# Baytex Manufacturing Co Ltd

## Keder Feeder - Alispan

### Rafter Modification

Alispan Rafter Eave End

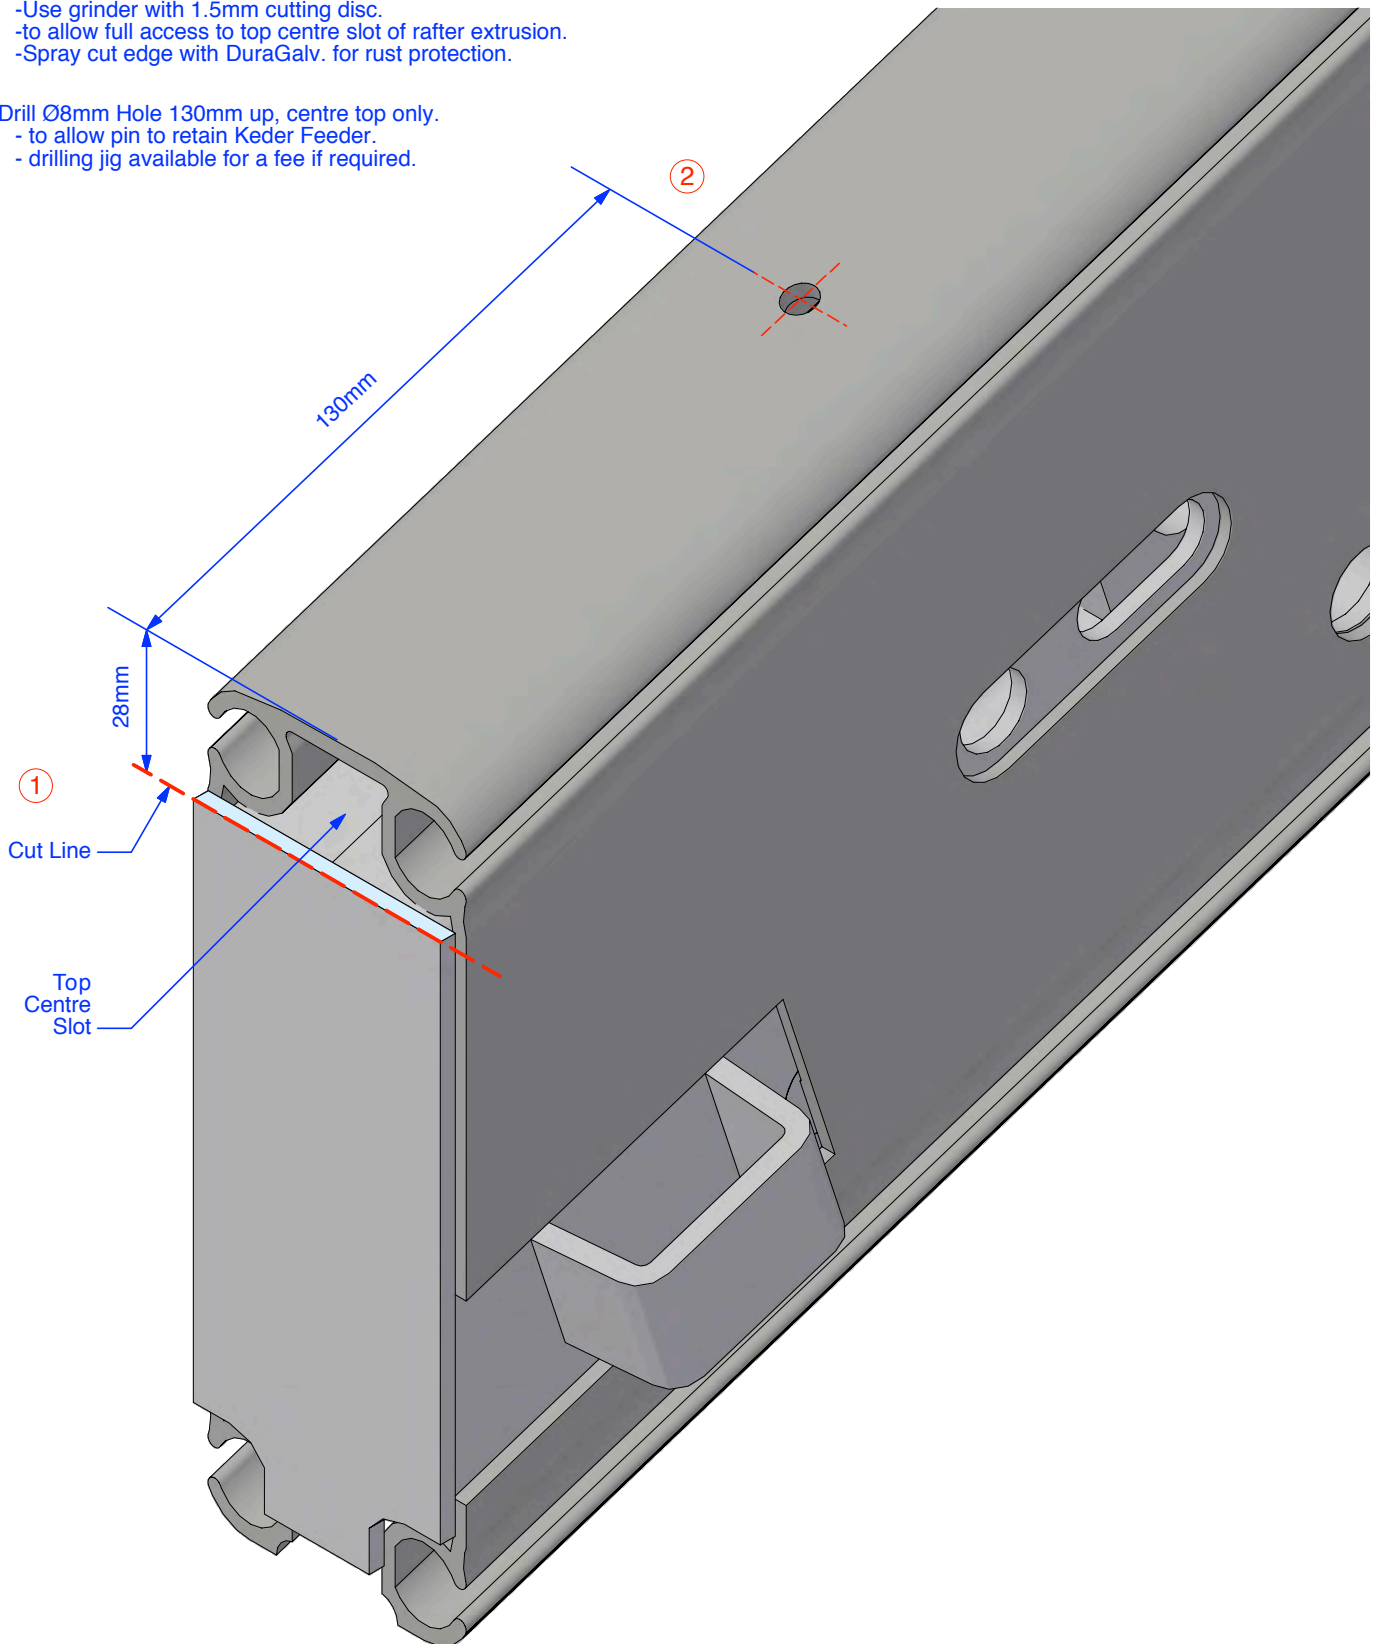
1. Cut Away Top Tab of End Eave Face Plate.
  - Use grinder with 1.5mm cutting disc.
  - to allow full access to top centre slot of rafter extrusion.
  - Spray cut edge with DuraGalv. for rust protection.
2. Drill Ø8mm Hole 130mm up, centre top only.
  - to allow pin to retain Keder Feeder.
  - drilling jig available for a fee if required.
